To: Spring Lake Park Planning Commission From: Phil Carlson, AICP, Stantec

File: Mr. Car Wash Date: March 28, 2022
 8200 Central Ave NE
 Applicant: Brittney Whitley, CWP West Corp
 Owners: Tam Le, Jin Yuan

Re: Conditional Use Permit, Preliminary Plat, Mr. Car Wash, 8200 Central Avenue NE

Mr. Car Wash 8200 Central Ave NE Spring Lake Park MN

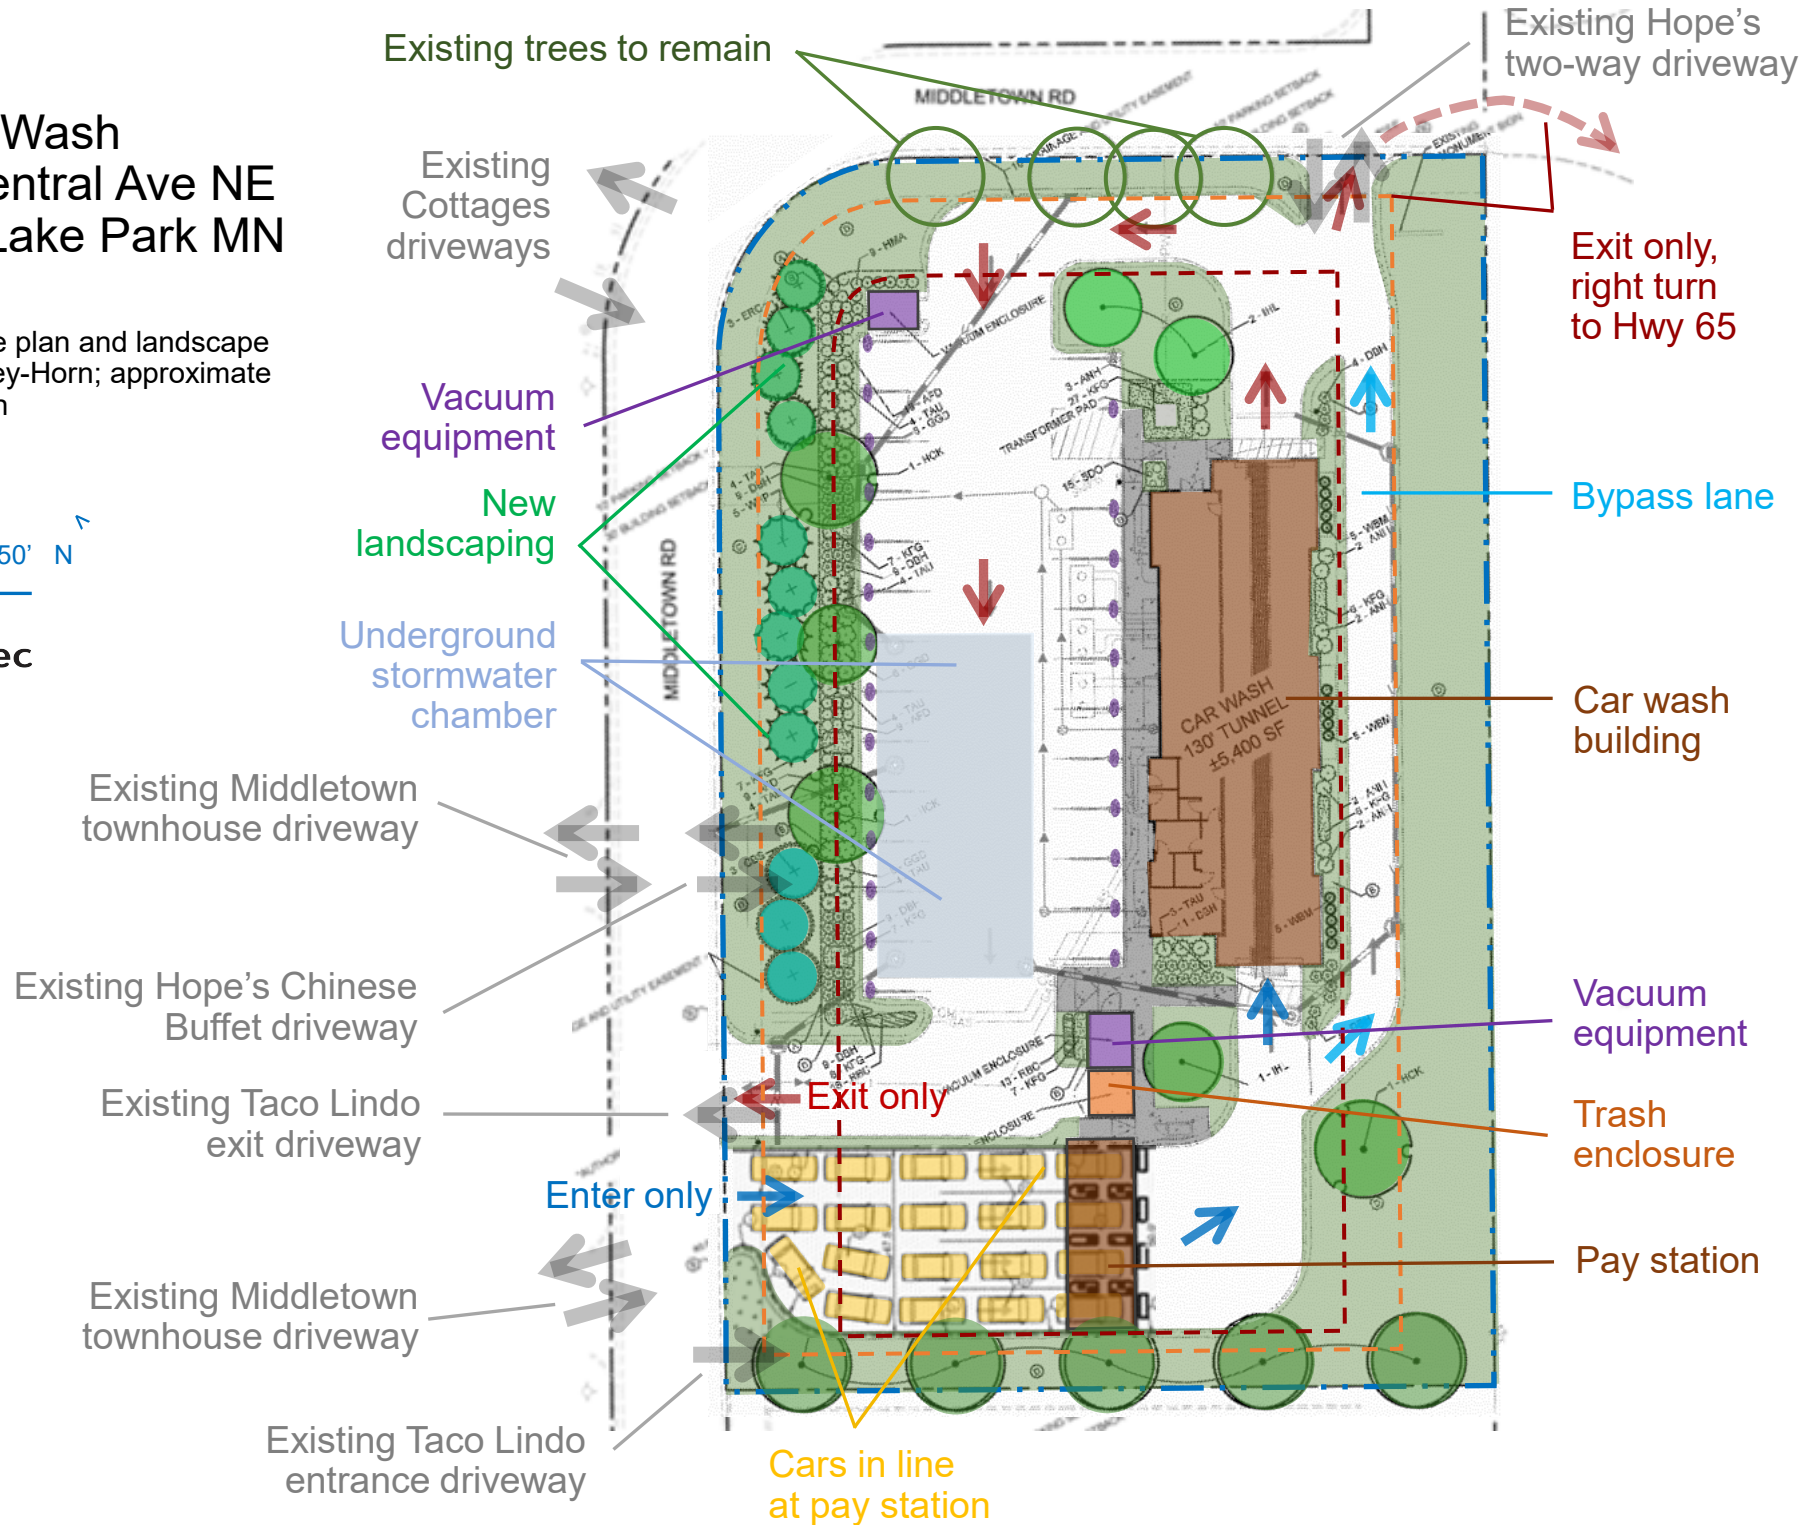
The access points described above are the three driveways for the site: one-way in at the SW corner of the site from Middletown Road, one-way out next to it from the parking/vacuum area, also onto Middletown Road, and one-way out at the NE corner of the site. It will be important to have clear signage so that traffic can be managed safely.

The current two properties have four driveways onto Middletown Road between them – separate entrance and exit driveways for Taco Lindo on the west side of the site, a two-way driveway for Hope's Chinese Buffet on the west side of the site, and a two-way driveway out the north end of the site for Hope's. The proposed Mr. Car Wash plan would replace these four with the three described above. Public works and engineering recommends that the north access drive, proposed as one-way out, be signed to only allow right turns onto Highway 65, and not allow traffic to go straight onto northbound Middletown Road. The existing and proposed driveways are illustrated on the site plan on the next page.

An issue with any drive-through type facility is adequate stacking and making sure that cars waiting in line don't interfere with cars on the adjacent street. The site plan submitted by the applicants shows 19 cars waiting in the pay station lines. This may be adequate, depending on their experience with their facilities. But on a very busy day cars may back up onto Middletown Road, or be tempted to do so. There needs to be clear signage so that stacking onto the road is not allowed and also a condition in the CUP that any traffic problems could result in review and revocation of the permit.

There are 24 parking spaces in front of the building in the parking/vacuum area. This would serve customers and staff for the facility. Spring Lake Park's parking standards require 10 spaces per lane in a commercial car wash. This facility may be different than what was imagined for a "commercial car wash" when the code was written. We recommend relying on the applicants' experience with their facilities to propose adequate parking.

- 3) The entry drive on Middletown Road will be signed as entrance only and indicating that no stacking is allowed onto the public street. If the City becomes aware of problems with cars stacking in the street or other traffic problems on site, the City Council reserves the right to review and potentially revoke the Conditional Use Permit.

Landscaping & Screening

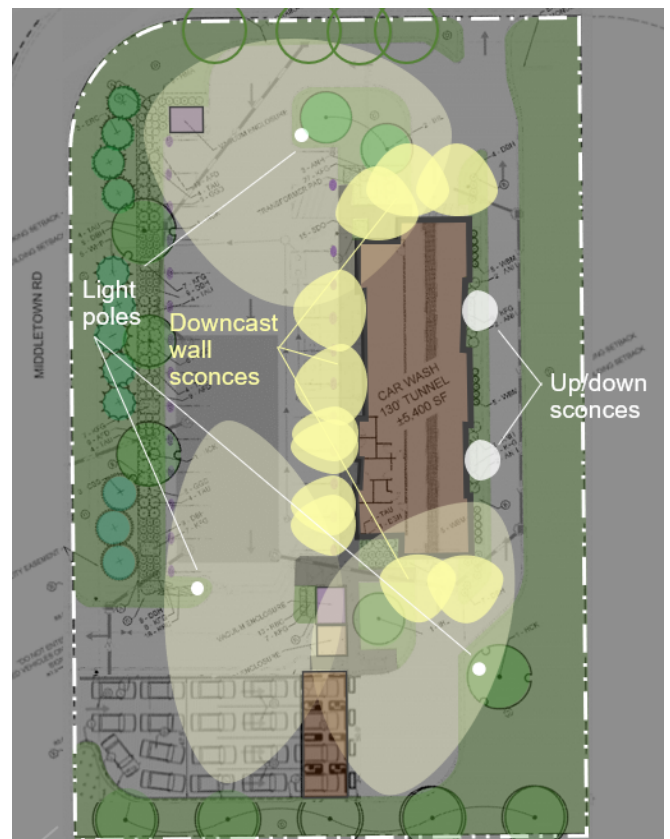
The landscape plan proposes significant landscaping on the west side of the site towards the existing townhouses, consisting of spruce, cedar and pine trees. There are large deciduous trees proposed in other parts of the site and four existing trees on the north side of the site are to be saved. There is a generous and varied complement of shrubs and perennials around the site and building as well.

The car wash operations are noisy, especially the blowers for drying, but they will be within the building and should be significantly muffled by the building and by the fact that the entry and exit doors face north and south, not toward the nearby residential uses. The vacuums can also be noisy and may need more muffling than would be provided by the proposed landscaping. We have asked for noise information from the applicants. Even if the site meets State standards a noise source can still be pretty annoying. We suggest some reasonable mitigation, which could include a solid fence or wall on the west side of the site to block noise. The graphic above right shows the site plan over an aerial. The purple area is where the vacuums are, the yellow lines are potential fence/wall locations to block the noise. The arrows show noise from four locations in the vacuum area. The orange arrows show noise that is directly blocked or at least muffled by the fence and red lines show noise that would get past the fences. With the two yellow fence lines suggested the only places noise would get directly through is to the south to other commercial uses, to the west at the driveway between the Middletown townhouses, and to the NW past the east edge of the Cottages. If we require a fence, we want it to block as much noise as possible but not block visibility for cars going in and out of the site.

- 1) Hours of operation will be 7:30 am to 7:00 pm.
- 2) If noise information from the applicants warrants additional sound mitigation, a solid fence or wall 6 feet in height will be installed on the west side of the site as illustrated in the Planner's report dated March 28, 2022, to block noise from the vacuum and parking area. The fence or wall will be of materials and colors compatible with the building, to be reviewed and approved by the City Administrator.

Lighting

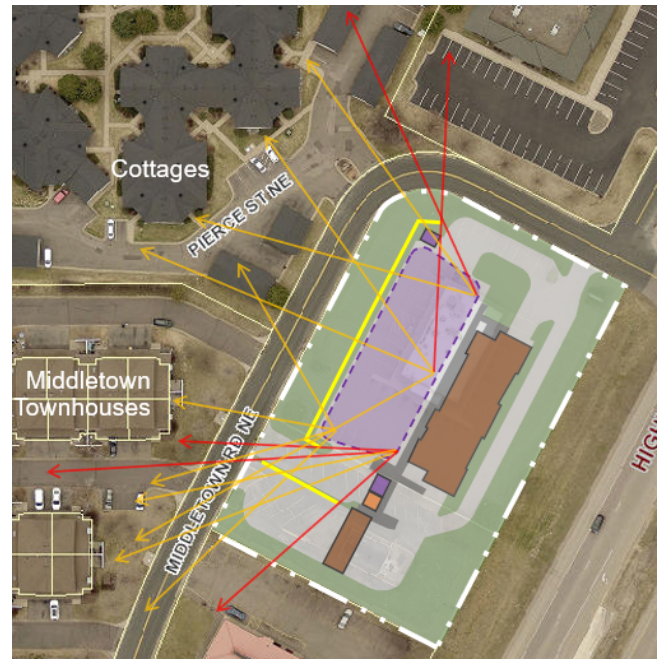
Lighting is proposed with wall-mounted fixtures on all sides of the building plus 20-ft tall light poles in three locations. All lights will be downcast cutoff type fixtures which will not spill more than 0.5 footcandle beyond the property lines or onto the public street. Initially the lights on the east side of the building facing Highway 65 were proposed as “up/down sconces” meaning that they would shine both up and down. We recommend there be no up lighting. The lighting scheme is illustrated, approximately, to the right.

- 5) All lighting will be downcast cutoff type fixtures that allow no more than 0.5 footcandle of light spillage beyond the property lines or onto the public road rights-of-way. This includes the up/down sconces proposed on the east side of the car wash building, which will not include any up lighting.
- 6) Signage will be submitted for a sign permit before a building permit is issued.
- 7) The driveway at the north side of the site will include signage indicating exit only and right turn onto Highway 65.
- 8) All landscaping will be installed as indicated on the landscape plan and guaranteed for at least one year.
- 9) All requirements of the City Engineer will be followed for engineering and utility issues prior to issuing a building permit.
